Rx58 Squelch	
TITLE: RD58_Squelch	
Document Number:	REV: 0.2.1
Date: 3/30/2005 23:45:14	Sheet: 1/1

DRAN BY: 0H8HB6  
 DEBUGGED WITH: 0H2L1Y

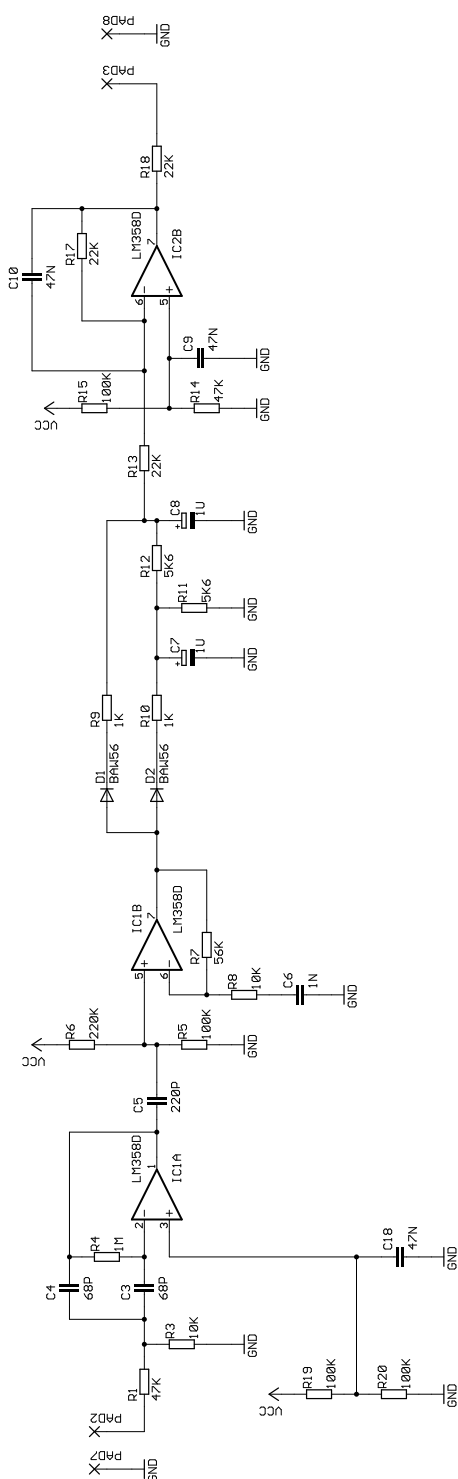
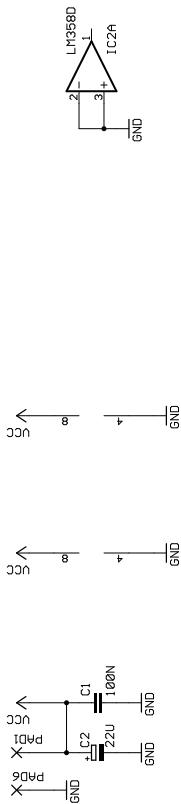
**POSSIBLE FAULTS:**

C5 should be >400 pF ??

Some timing problem in squelch tail (C7, C8,...)

If squelch level constant, check DC levels of opamps first!
